ADDENDUM NO. 1
WASTEWATER TREATMENT PLANT IMPROVEMENTS
CONTRACT 18-01
CHLORINE CONTACT BASIN RENOVATION
TOWN OF HUNTINGDON, TENNESSEE
WAUFORD PROJECT NO. 3644

Date of Addendum: Monday, October 15, 2018
Bid Opening: Thursday, October 18, 2018, 10:00 A.M. Central Time

1. PLANS, Sheets 2 & 3:

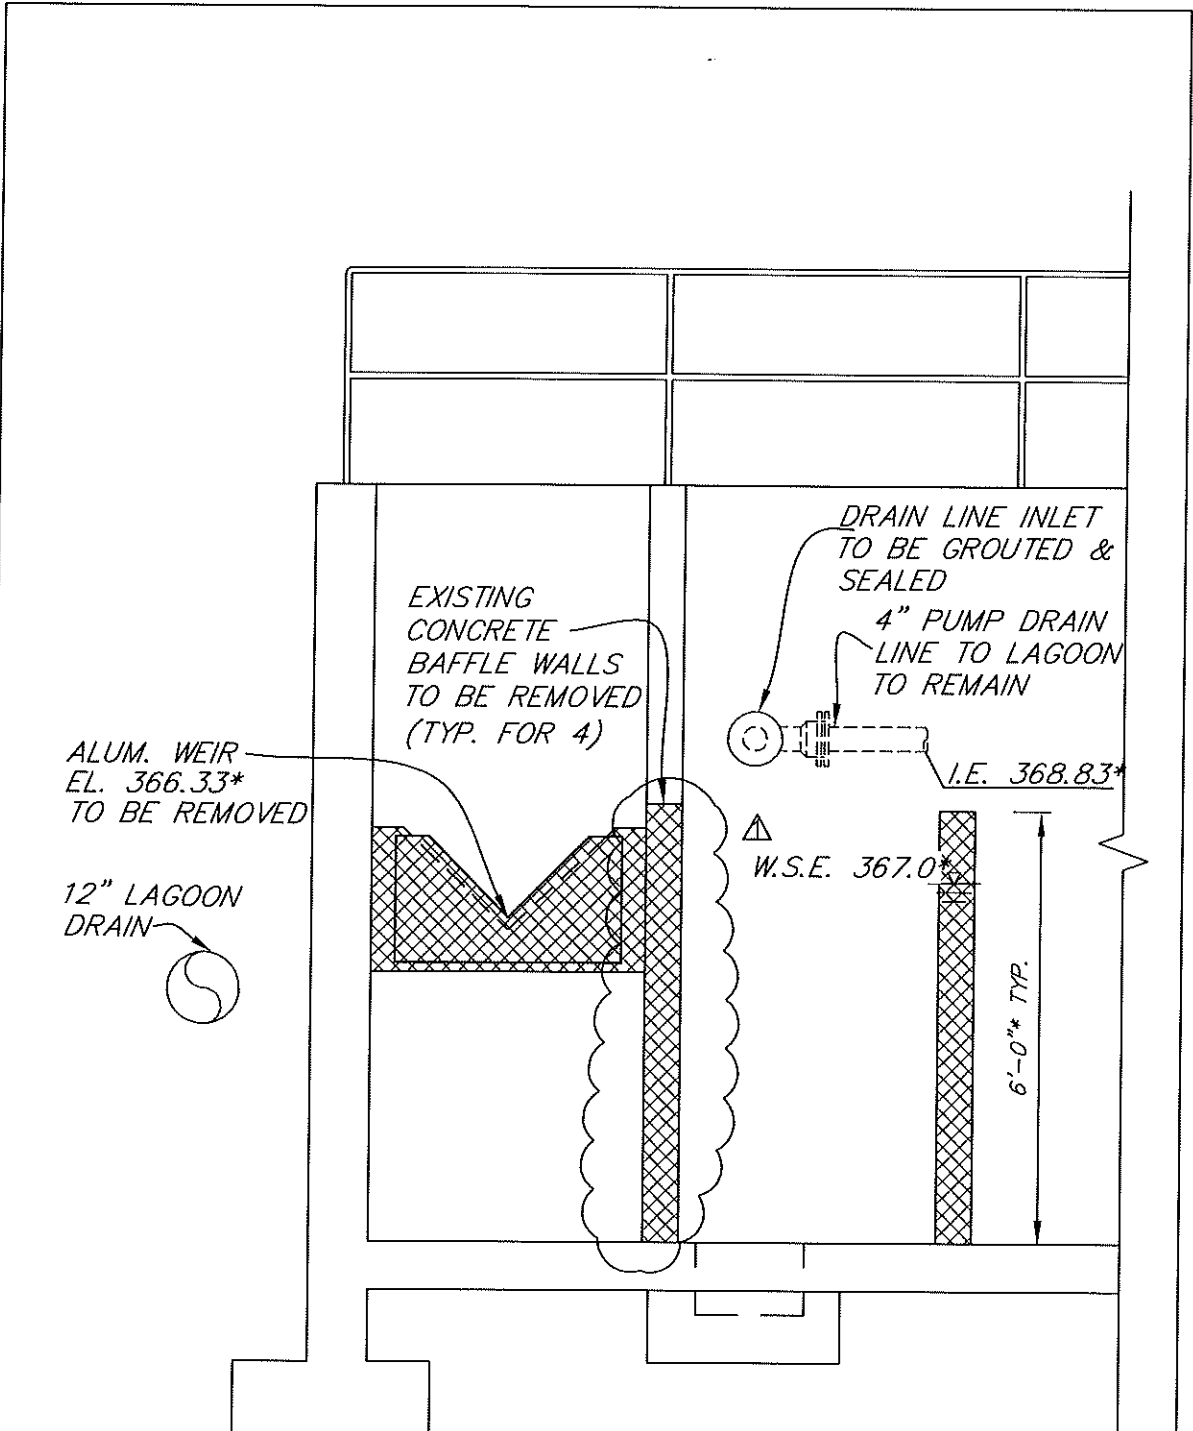
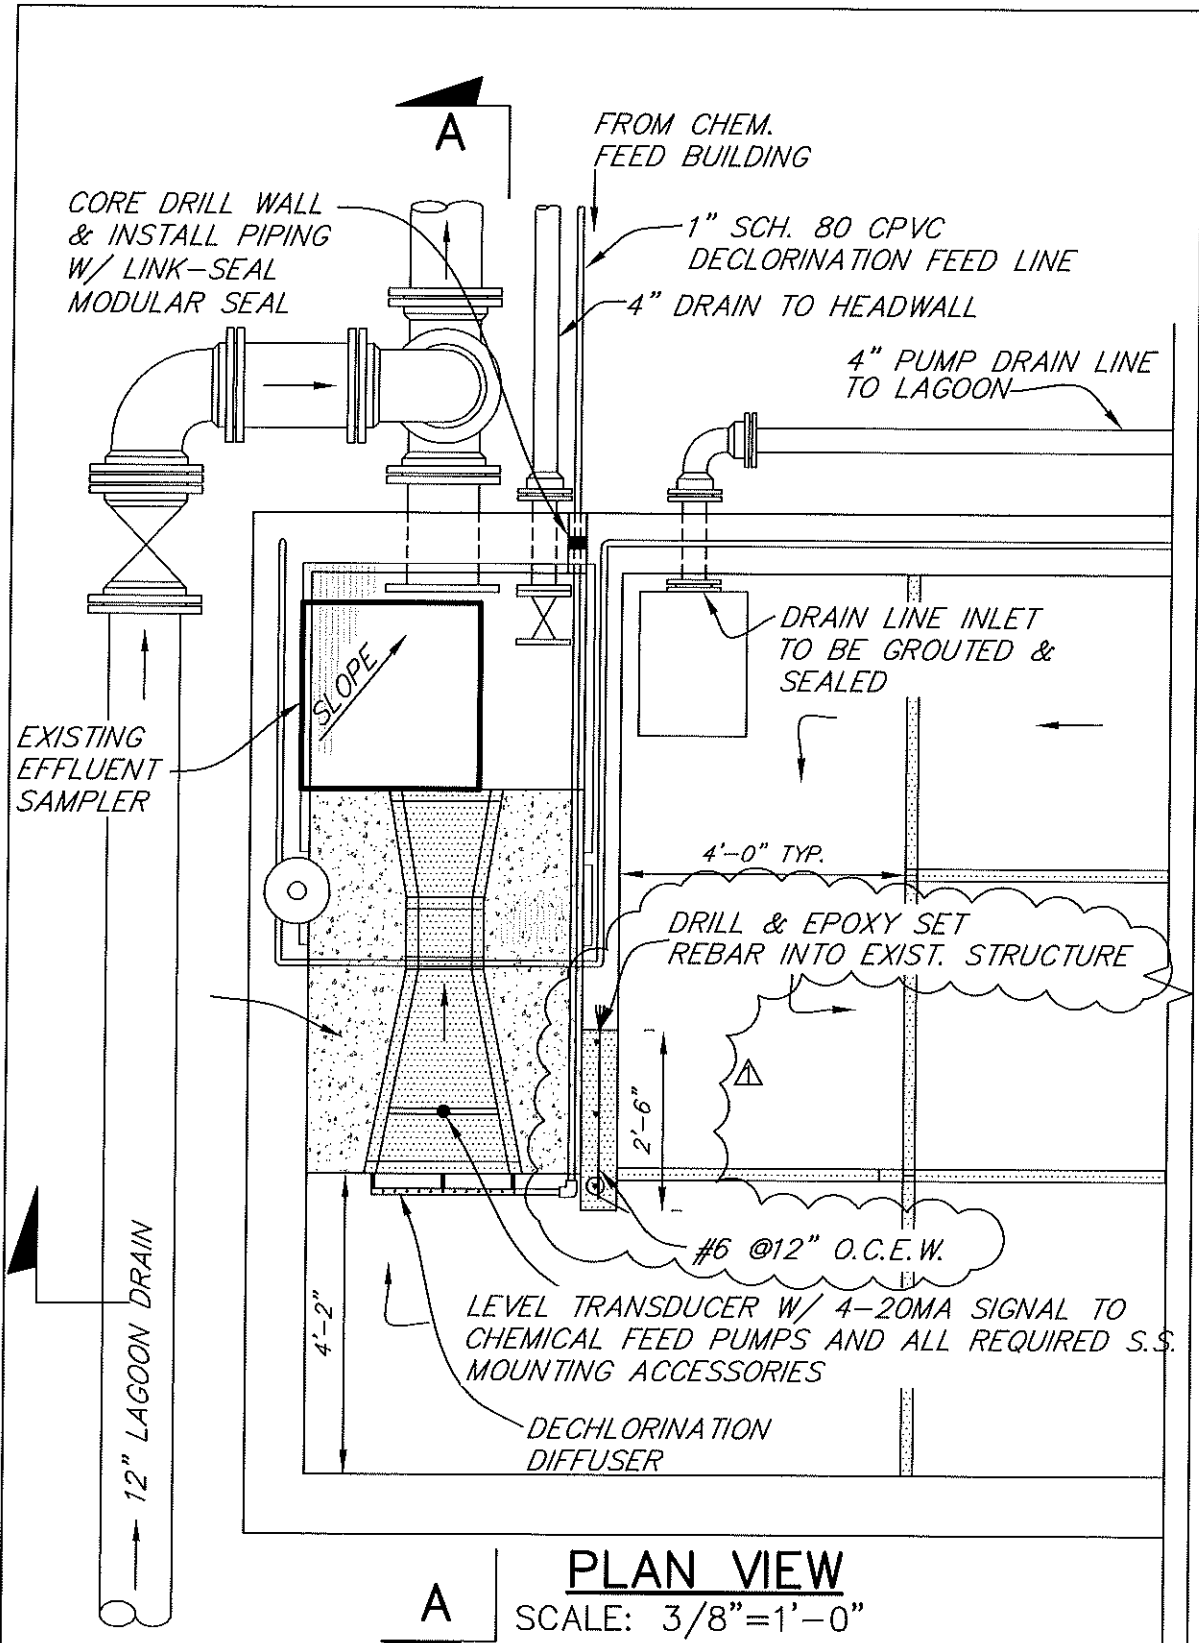
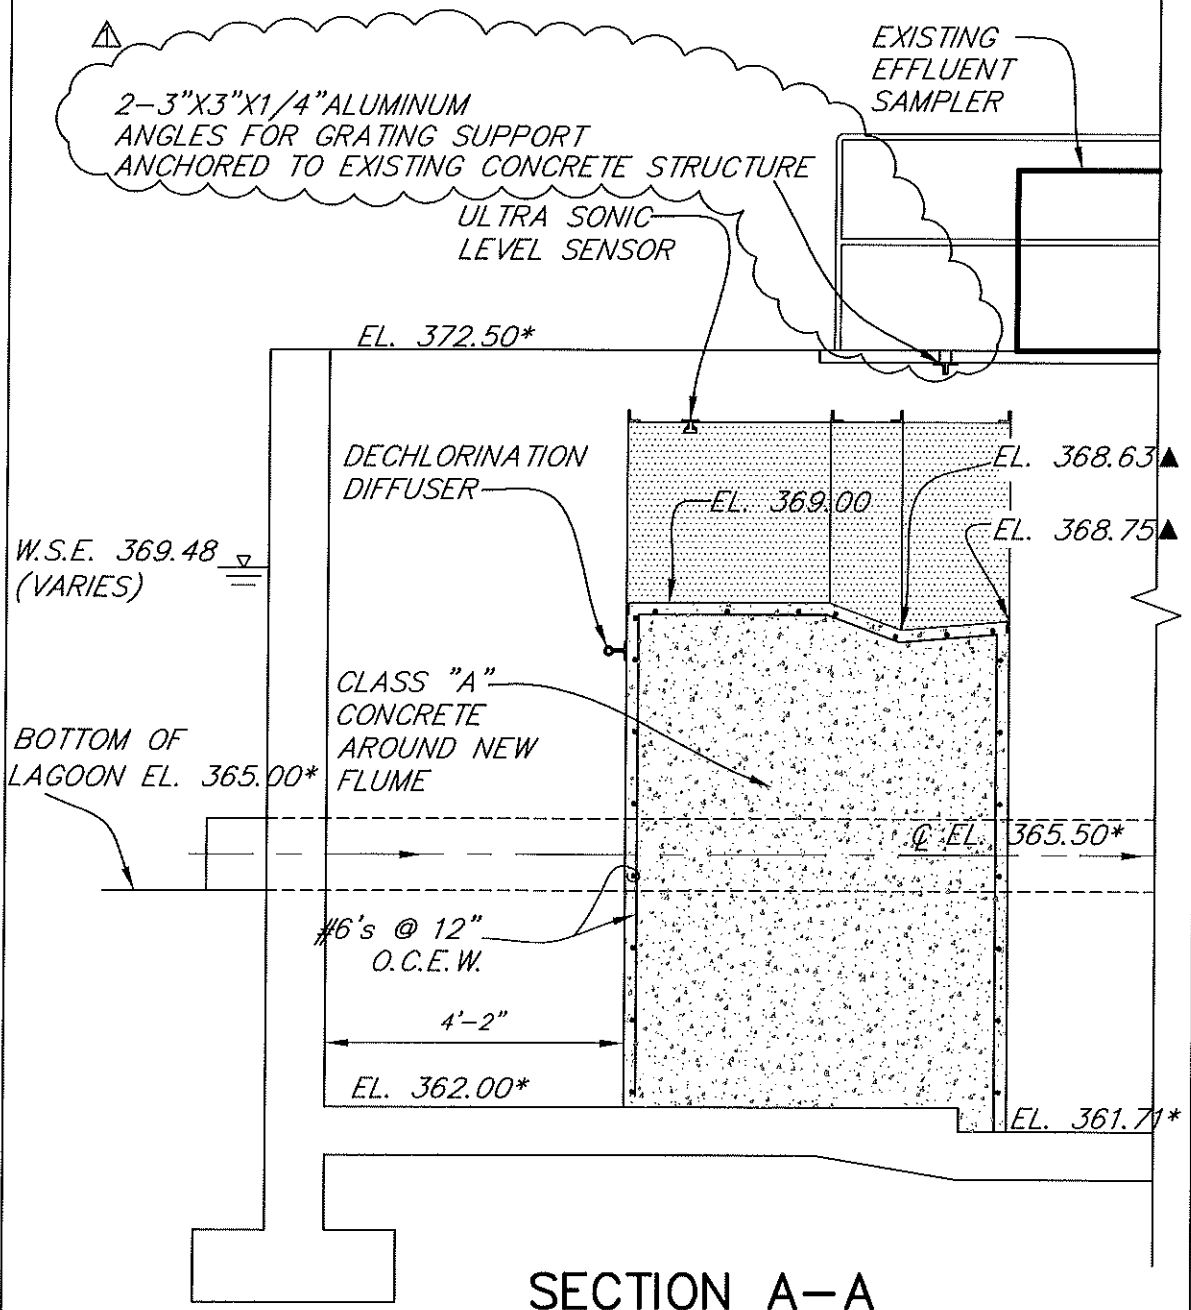
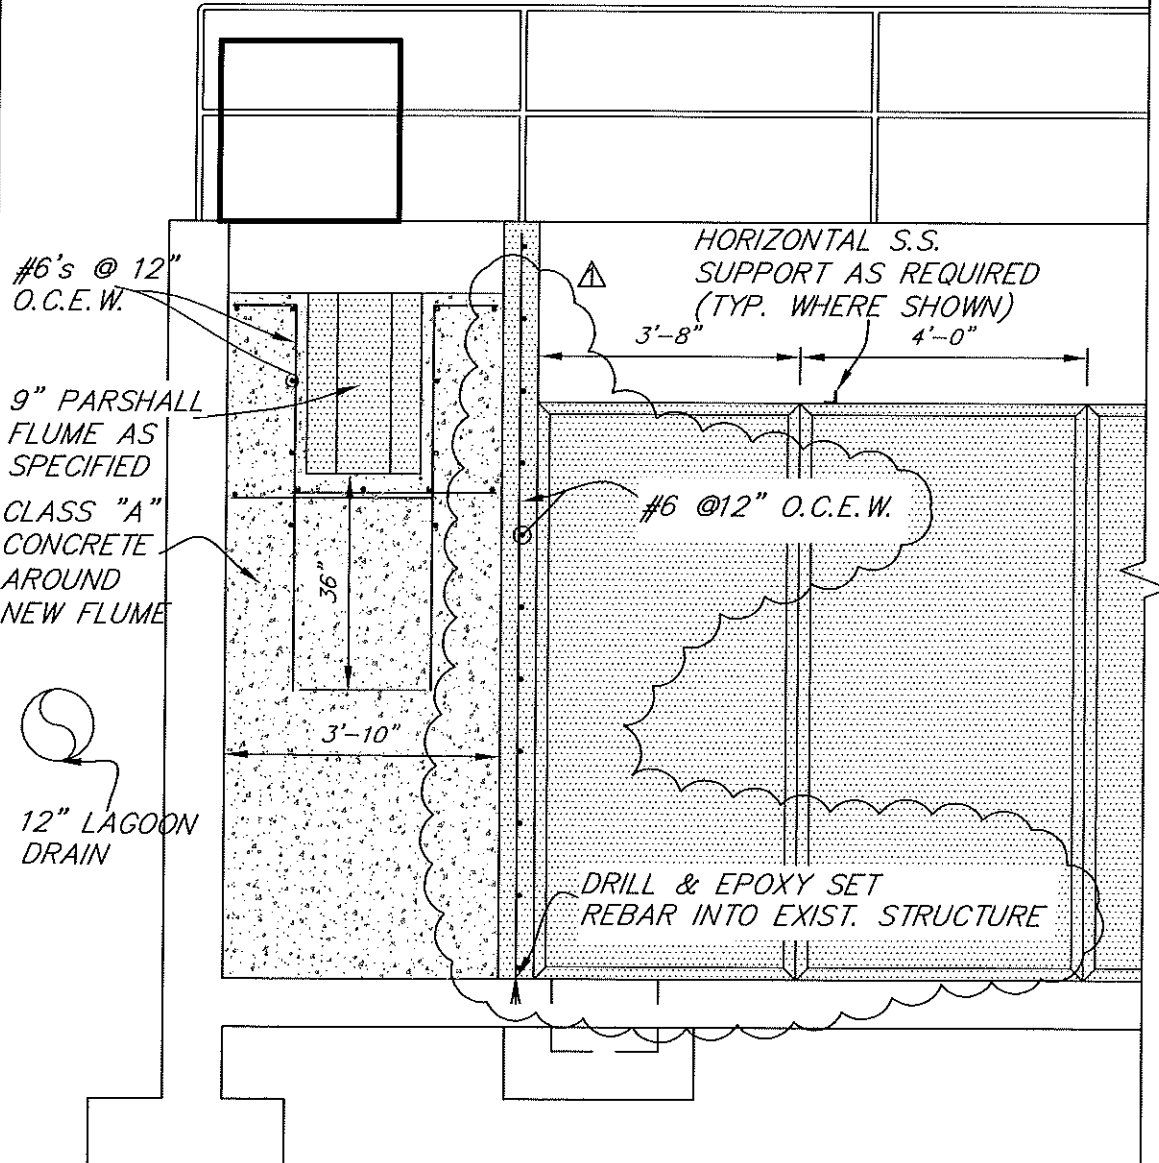
Attached are revised plans to the Parshall Flume area of the structure. They include grating support and concrete wall extension.
